SUBJECT: PUBLIC HEARING TO CONSIDER AN APPEAL OF THE PLANNING COMMISSION'S APPROVAL OF APPLICATION NO. 99-0079, A PROPOSAL TO DIVIDE AN EXISTING PARCEL INTO TWO PARCELS. REQUIRES A MINOR LAND DIVISION. PROPERTY LOCATED ON AN UNNAMED RIGHT-OF-WAY APPROXIMATELY 1/3 MILE WEST OF CALABASAS ROAD; APTOS HILLS PLANNING AREA; APN 049-441-05; APPLICATION NO. 99-0079; OWNERS AND APPLICANTS: CLIFFORD LOW AND PRISCILLA PARTRIDGE

STAFF REPORT TO THE PLANNING COMMISSION

TENTATIVE PARCEL MAP OF ASSESSOR'S PARCEL NO. 048-111-45	
Scale 1" = 80' February 1, 1999	Santa Cruz County California File 980387.DWG FB 113/9
Prepared for Clifford Low & Priscilla Partridge Revised 2/1/99: Added cross section, culverts, turnaround, etc. 8/31/99 bldg env, driveway grade.	
1512 SEABRIGHT AVENUE-SUITE A SANTA CRUZ, CA 95062 PHONE (408) 425-1796 FAX (408) 425-1795	Job #8038

TENTATIVE PARCEL MAP	
OF ASSESSOR'S PARCEL NO. 04-111-45	
Santa Cruz County, California	
Scale 1" = 80'	File 980387.DWG
February 1, 1999	FB 113/9
Prepared for	
Clifford Low & Patricia Portillo	
Reviewed 2/1/99	
Revised 2/1/99	
Job #9038

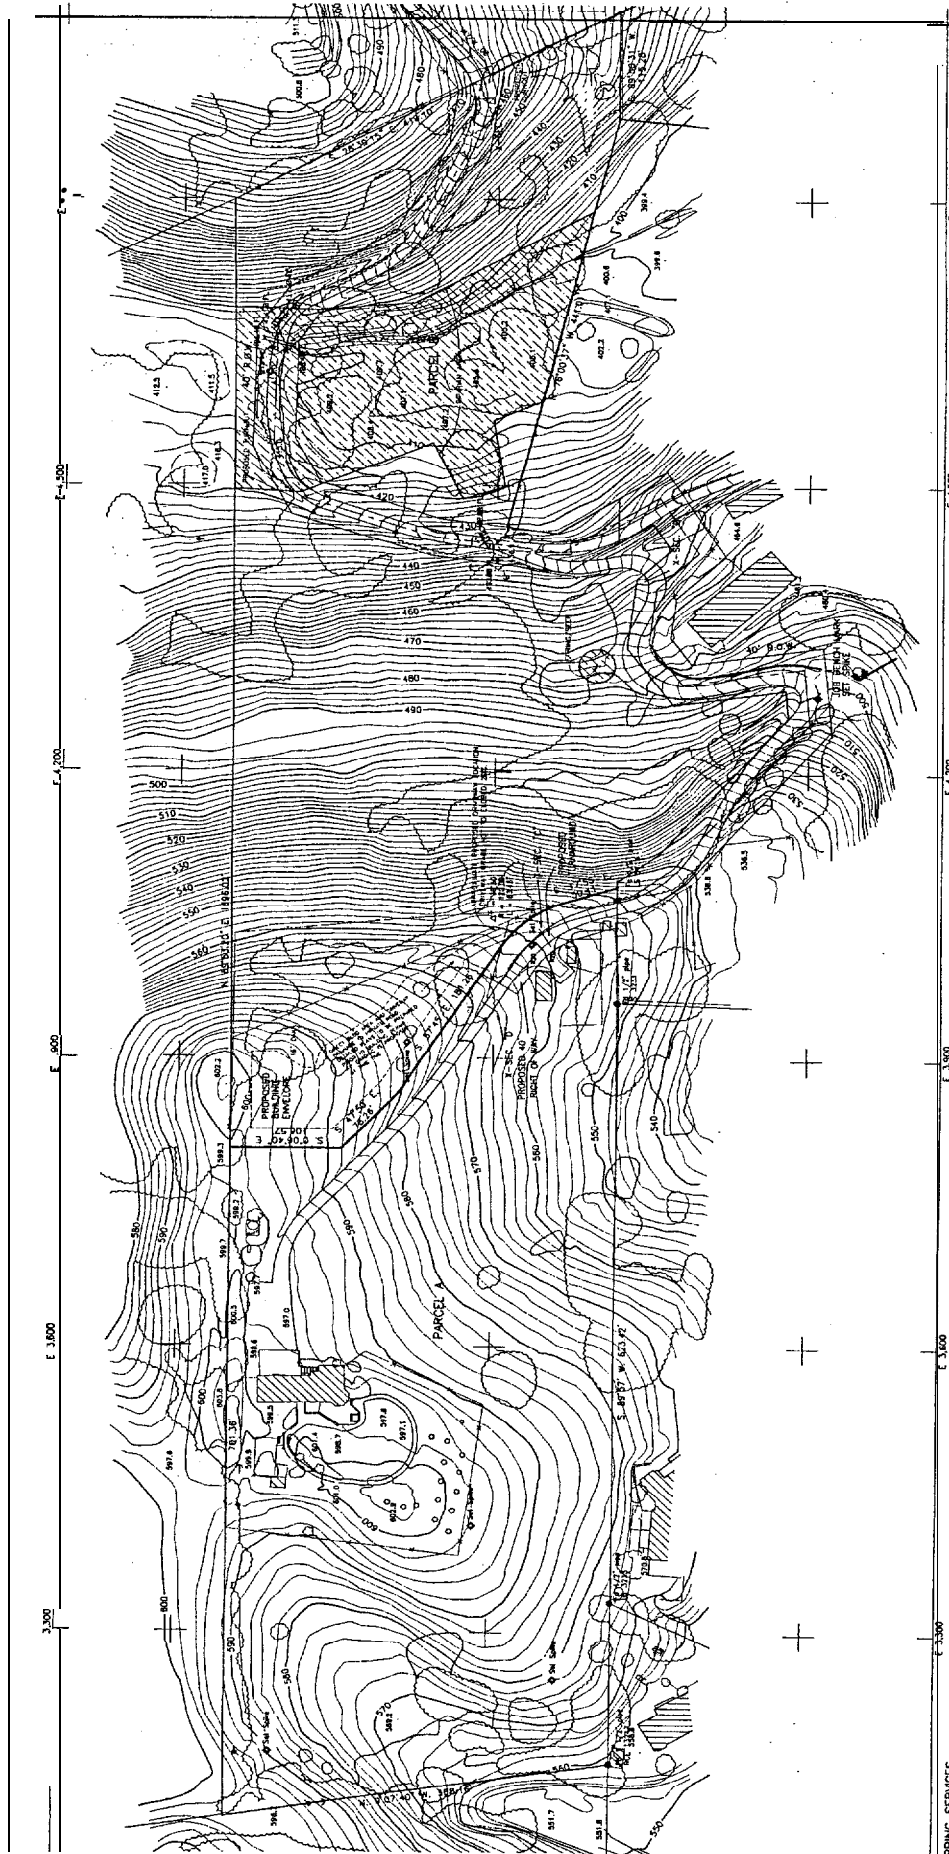
Contact Mike Snyder at 335-6748 with any questions.
Revised plans show Fire Dept. turnouts & turnaround on a 12' wide road. This will provide adequate access in lieu of an 18' wide road. This revised plan is approvable as submitted.

It is recommended that the site plan include the access road out to Calabassas Road. The access road is recommended to be 18 feet wide to serve two lots upto the point where the new driveway turns off to the right.
6/30/99 - Same comments apply.

It is recommended that the access road be improved to 18 feet wide to accommodate two-way traffic. The access road should be shown all the way out to Calabassas Road, and indicate the number of lots served by the road. There are no TIA fees in the Aptos Hills planning area.
6/30/99 - Same comments apply.

TENTATIVE PARCEL MAP / SLOPE ANALYSIS		OF ASSessor's PARCEL NO. 049-111-45	
1" = 50'	Santa Cruz County California	File: 180219.Dwg	1/3 11/2/9
Prepared for		1/3 11/2/9	
Clifford Low & Priscilla Partridge		1/3 11/2/9	
Sheet 2 of 2 Sheets		1/3 11/2/9

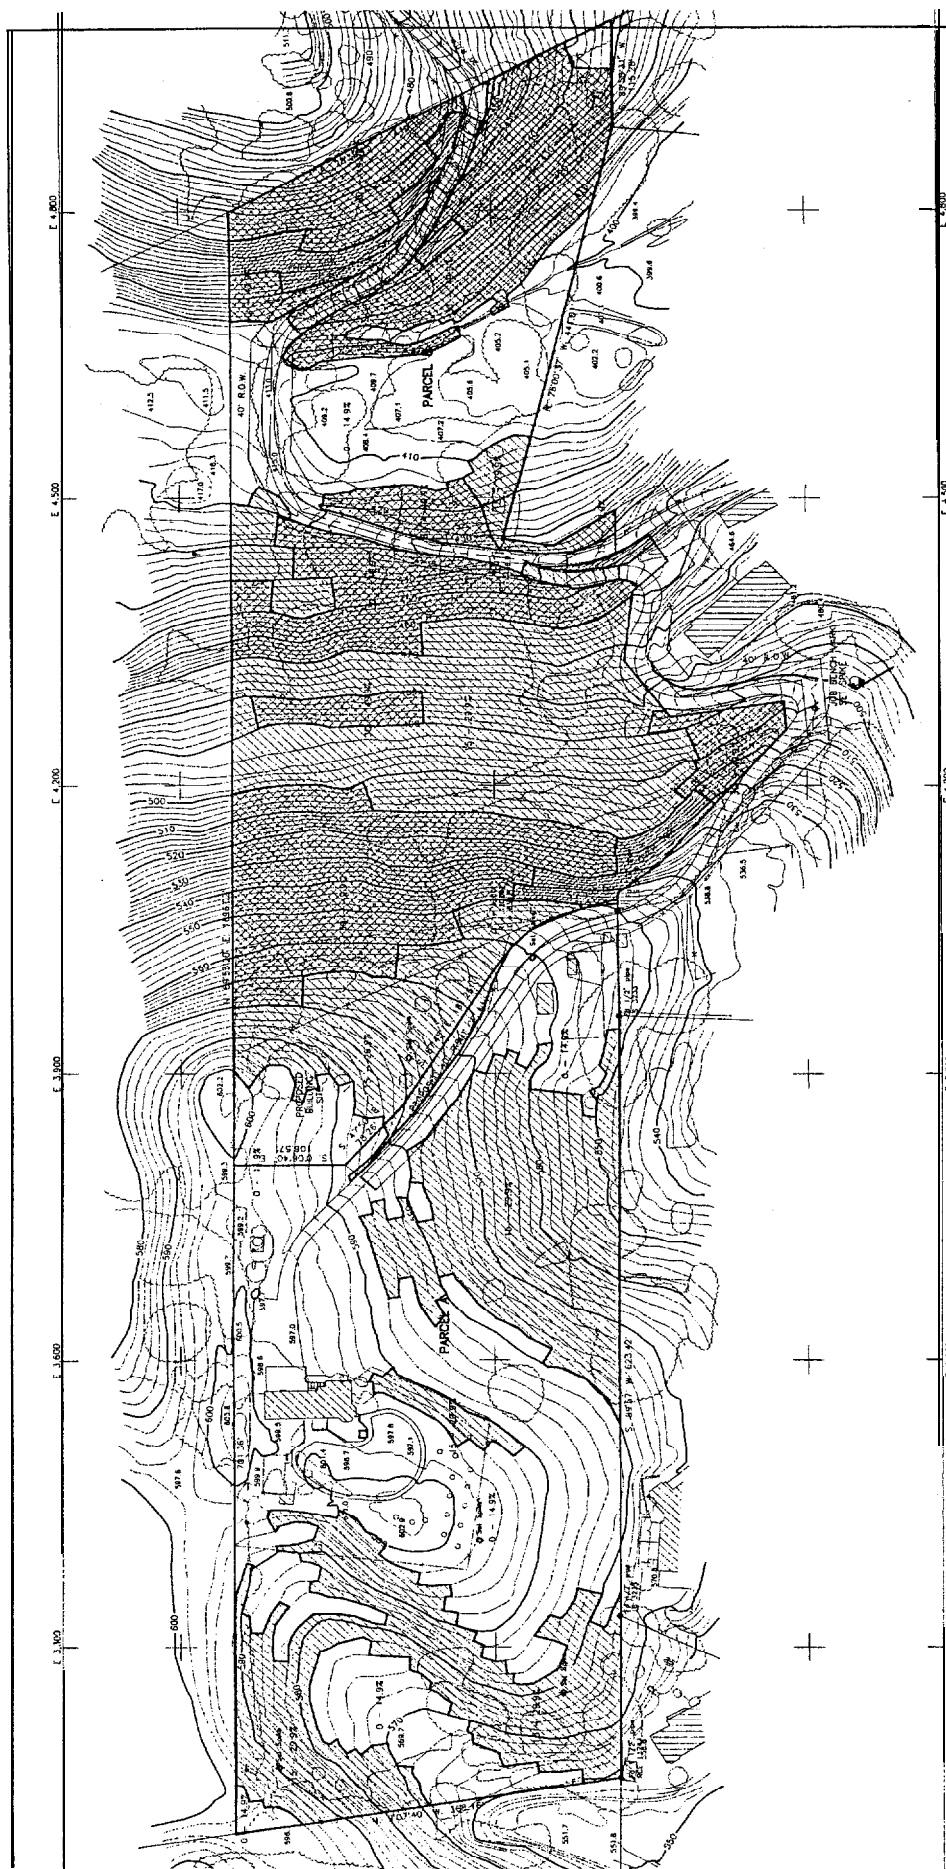
Planreviewed: Tentative Parcel Map, revised 8-31-99

The revised building envelope satisfactorily addresses the slope and grading issues from my earlier memos. The application may be deemed complete as far as Environmental Planning is concerned. Please include the following as development permit conditions:

With land division improvement plans (if any), or otherwise with building permit plans, an engineered design shall be provided for correction of the erosion condition where a culvert has failed. This is located east of the creek along the north side of the access driveway.
